30-005-20754

WESTERN HOLLY 32 STATE

SUNDRY NOTICES AND REPORTS ON WELLS

MARATHON OIL RESPECTFULLY SUBMITS THIS NOI TO PXA PER MARATHON'S AGREEMENT WITH THE NMSLO.

CURRENT

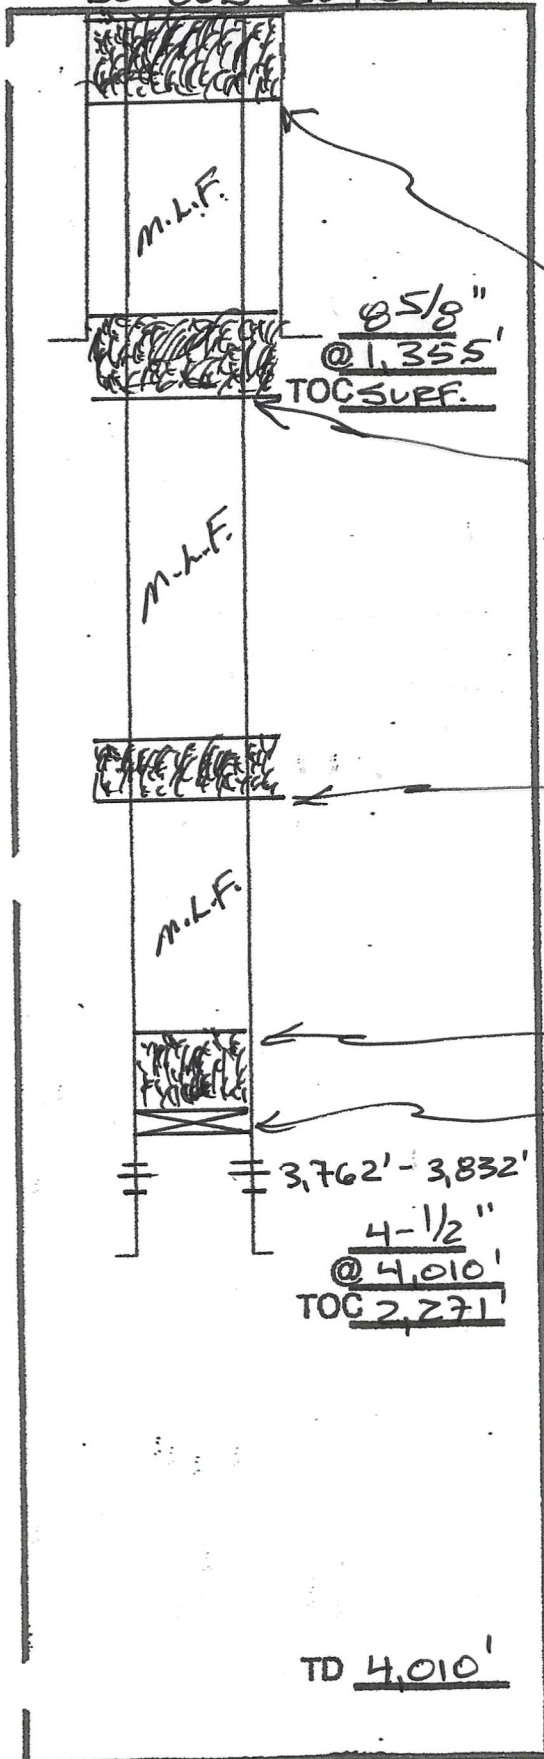
- Bubble test
 1) SET 4-1/2" CIBP @ 3,750'; CIRC. WELL W/ M.L.F. X PRES. TEST 4-1/2" CSG. TO 500# X HOLD. Run CBL
 2) PUMP (80) SXs. CLASS "C" CMT. @ 3,750'-2,922' (T/S.A.). WOC & Tag
 3) PERF. X ATTEMPT TO SQZ. (45) SXs. CLASS "C" CMT. @ 1,894'-1,784' (T/YATES, B/SALT); WOC X TAG TOC.
 4) PERF. X ATTEMPT TO SQZ. (55) SXs. CLASS "C" CMT. @ 1,444'-1,290' (T/SALT, T/ANHY., 8-5/8" SHOE); TAG.
 5) PERF. X CIRC. TO SURF., FILLING ALL ANNULI, (30) SXs. CLASS "C" CMT. @ 1000'-X'. 200' - surface
 6) DIG OUT X CUT OFF WELLHEAD 3' B.G.L.; VERIFY CMT. TO SURF. ON ALL ANNULI; WELD ON STEEL PLATE TO CSGS. X INSTALL BELOW GROUND DRY HOLE MARKER.

SEE ATTACHED COA's

MUST BE PLUGGED BY 11/1/24
